PJM Manual 07:

PJM Protection Standards

Revision: 5

Effective Date: September 25, 2025

4.2.1 Acceptable and Prohibited System Configurations

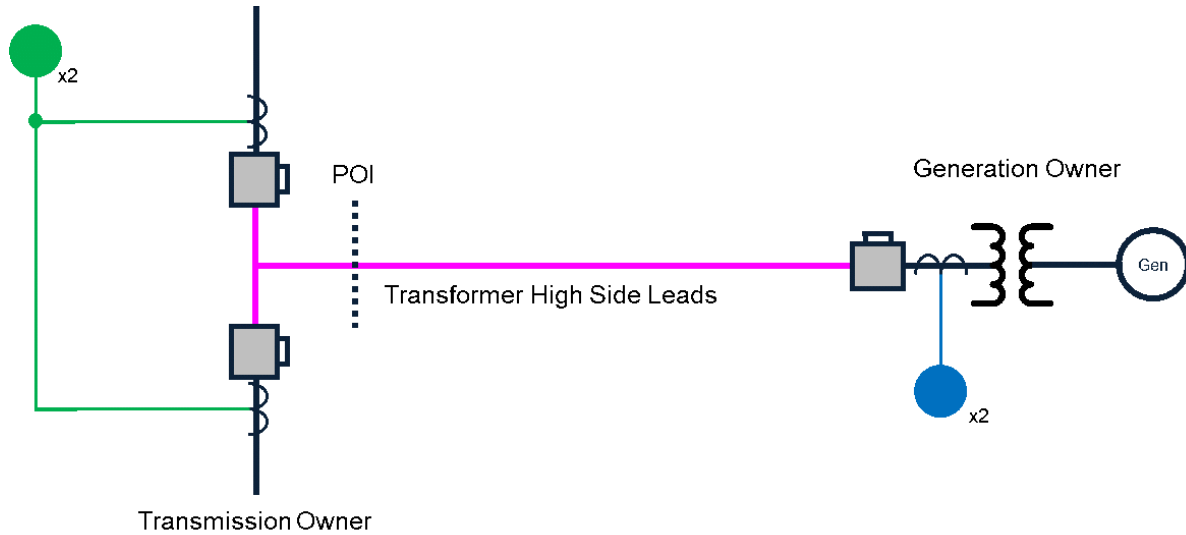
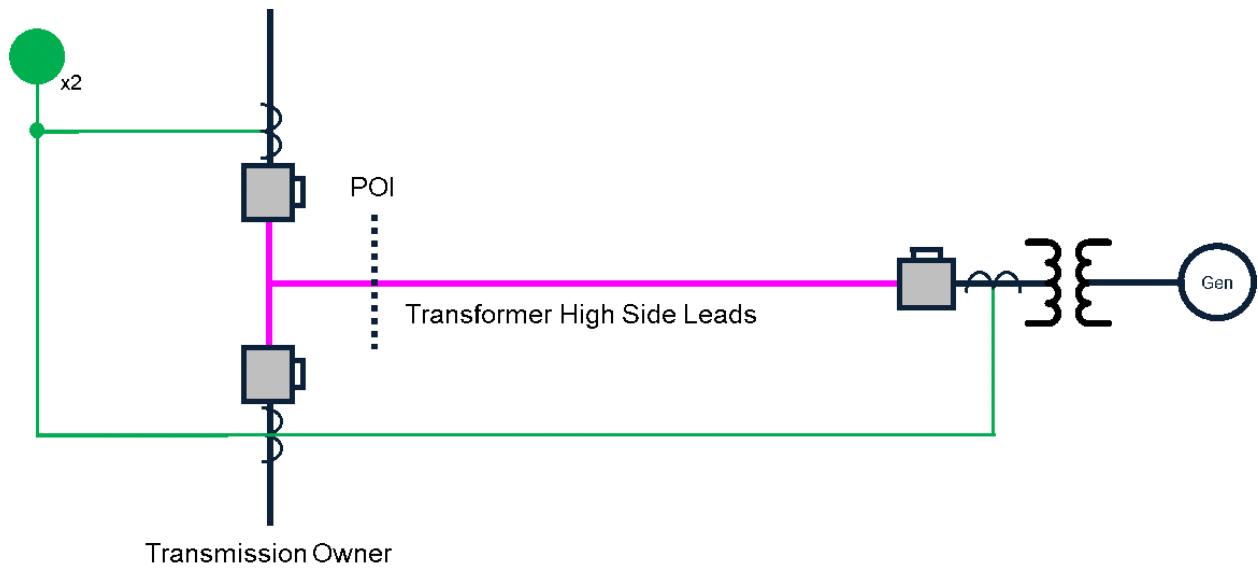
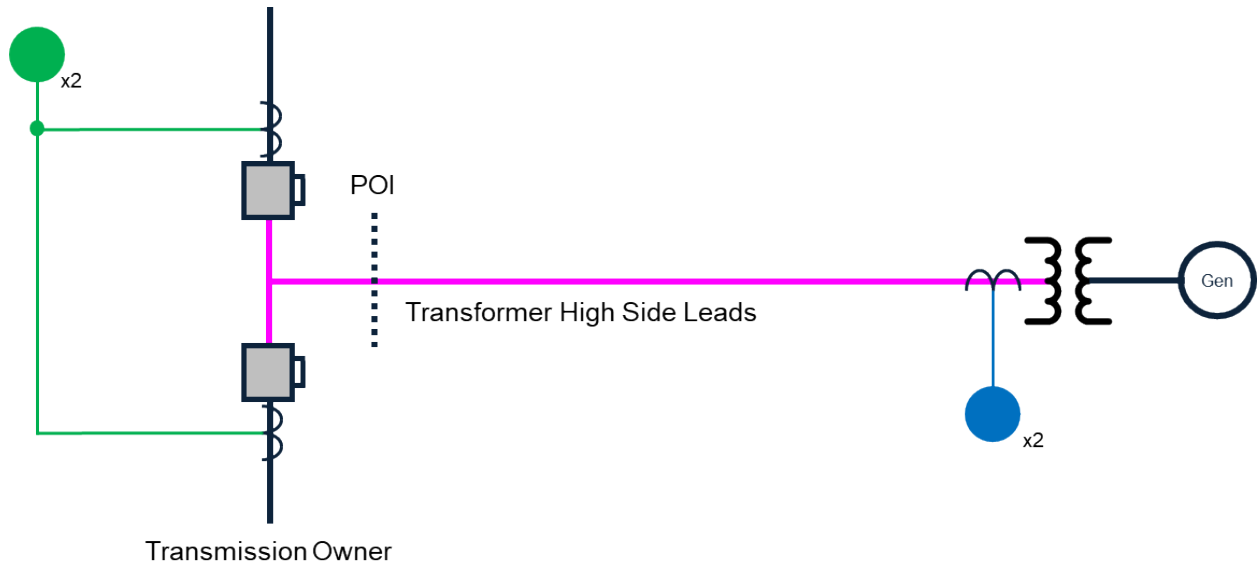
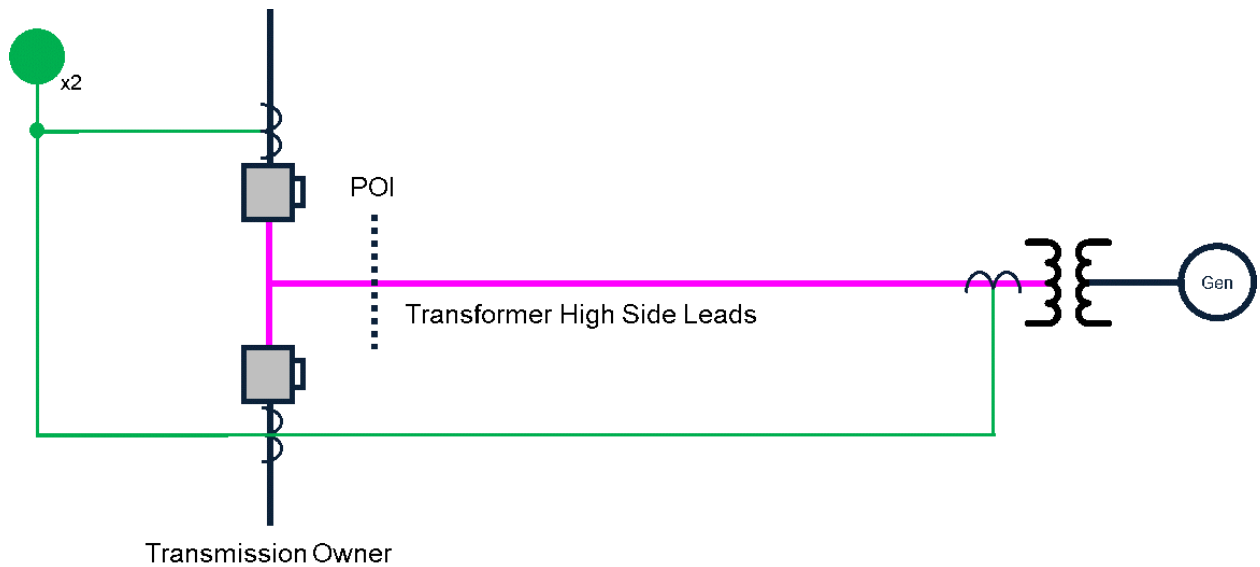
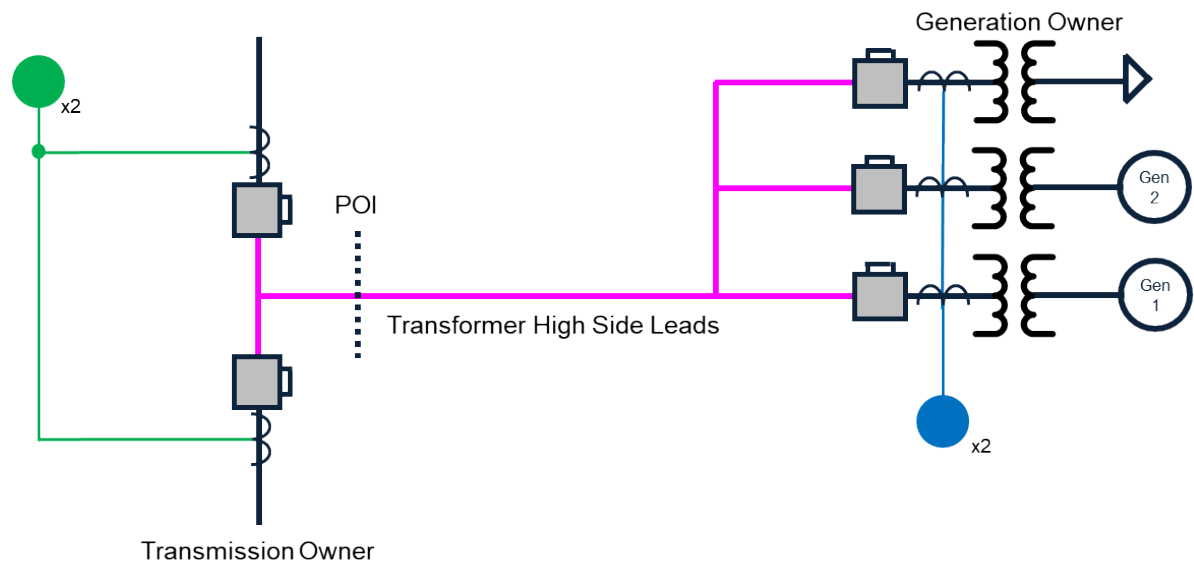
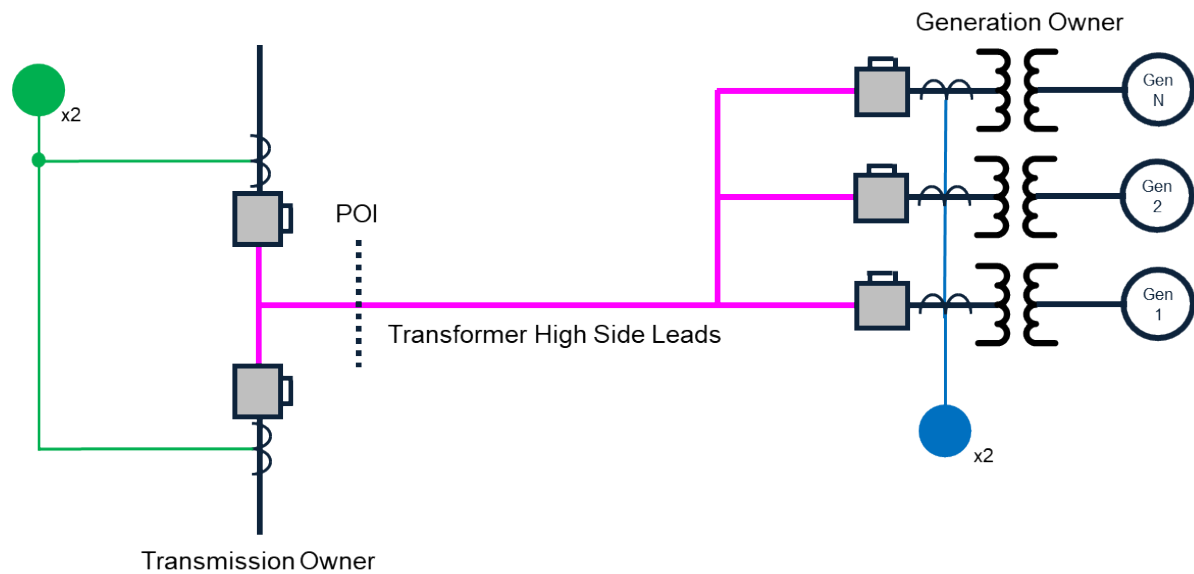
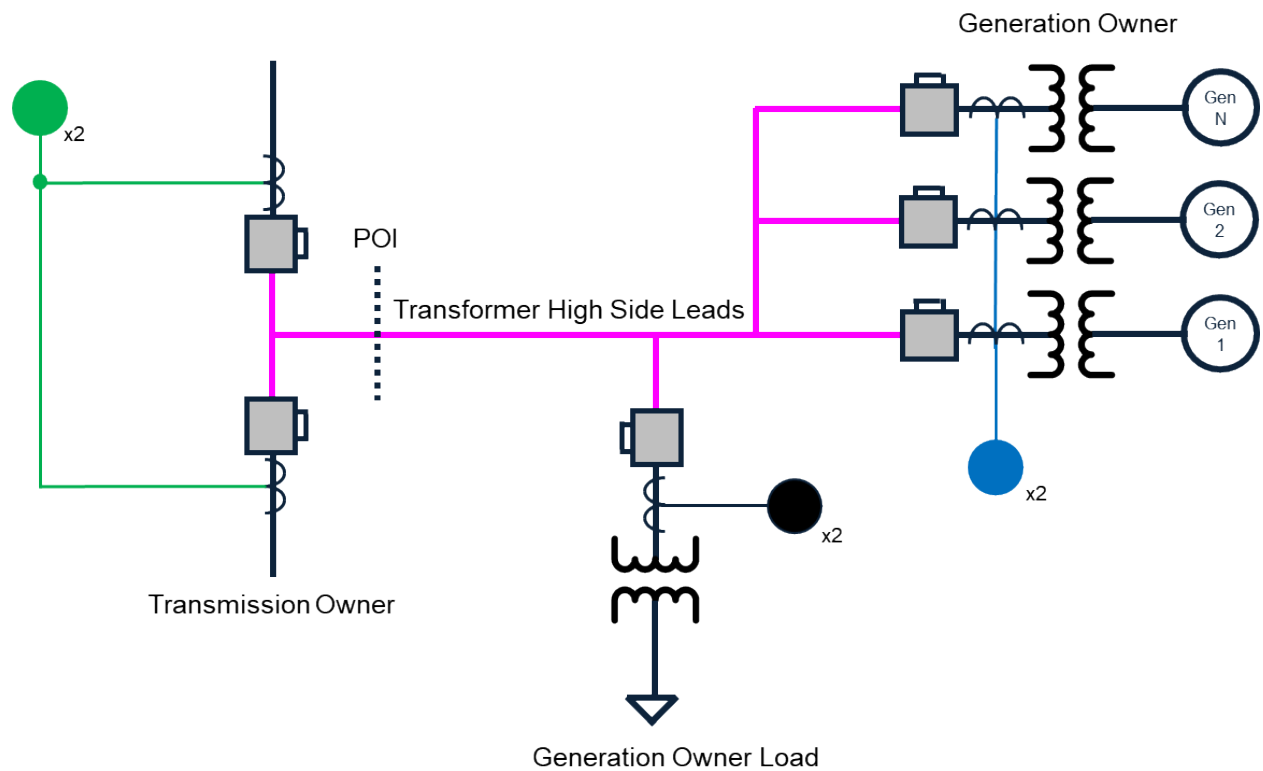
- Enhanced section 4.2 on transformer high-side lead protection with more details and added reference diagrams
- Enhanced Section 7.4 on Restricted Ground Fault Protection to mention sensitivity and contextualize specific tripping times

The transformer high-side leads are required to be protected by two independent current differential schemes ~~or equivalent high-speed schemes~~. The schemes must utilize independent current sources and independently protected DC control circuits.

Transformer high-side leads shall not have infeed within the protection zone as experienced by the two independent current differential schemes. Transformer high-side leads shall not have more than two terminals as experienced by the two independent current differential schemes.

In Section 4.2.1 several examples of acceptable configurations are provided; this is not an exhaustive list. Other configurations of both the protection and phase conductor are possible while satisfying the requirements. Additionally, Section 4.2.1 provides a possible system configuration that is prohibited.
